Access Compliance Report Public Rights-of-Way (Curb Ramps)

Main Street: ST_VINCENT_PL Cross Street: BIMINI_DR Location: W

ADA ID: RPRK211013145234 Ramp Type: Type 6 - Directional 1 Initial Pass/Fail: Pass Overall Compliance: No Severity Score: 10

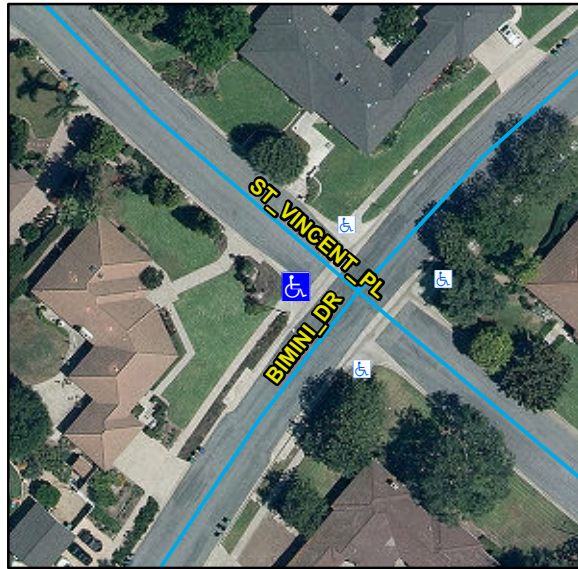
Compliance	Description	Data	Compliance	Description	Data
N/A	Ramp Length (in)	128	N/A	Flare Type LT	
Yes	Ramp Width (in)	88			Sloped
Yes	Ramp Run Slope (%)	1.8	N/A	Flare Slope LT (%)	6.5
Yes	Ramp Cross Slope (%)	1.4	N/A	Flare Traversable LT	No
Yes	Grade Break	Yes	Yes	Flare Type RT	
Yes	Grade Break Slope (%)	2			Curbed2
Yes	Grade Break Cross Slope (%)	2.5	N/A	Flare Slope RT (%)	N/A
	Addl Para Ramp Left?	No	N/A	Flare Traversable RT	N/A
	Addl Para Ramp Right?	No	No	DWS Provided	No
N/A	Landing Present	Yes	N/A	DWS Contrast	N/A
Yes	Landing Length (in)	53	N/A	DWS Length (in)	N/A
Yes	Landing Width (in)	48	N/A	DWS Full Width	N/A
No	Landing Run Slope (%)	2.2		DWS Offset Type	N/A
Yes	Landing Cross Slope (%)	2.5	N/A	DWS Left Offset (in)	N/A
N/A	Landing Movement Obstructed?	No	N/A	DWS Right Offset (in)	N/A
	Landing Movement Type	N/A			
N/A	Landing Shared	No			
N/A	Marked Crosswalk 1	No	N/A	Clear Space	N/A
	Crossing 1 Direction	NE	N/A	Clear Space To Crosswalk (in)	N/A

Marked Crosswalk 1 Width (in)	N/A			
N/A	Ramp Inside Crosswalk 1	N/A			
	Crossing 1 Slope (%)	1.2			
	Crossing 1 Cross Slope (%)	3.5			
Yes	Gutter Ponding	No	Yes	Curb Slope	3.8
Yes	Gutter Lip Height (in)	0		Road Run Slope (%)	N/A
Yes	Gutter Run Slope (%)	1.7		Road Cross Slope (%)	N/A
Yes	Gutter Cross Slope (%)	2.2		Parallel Ramp Side	Right
Yes	Overall Surface Condition	Acceptable	Yes	Perp Joint Present	Yes
	Cross Gutter Present?	Yes		Spandrel Present?	Yes
	Replace Cross Gutter?	No		Replace Spandrel?	No

Possible Solutions:

Remove & Replace Entire Ramp.

R304.2.2-Perp, R304.3.2-Para, R305, STD 1115
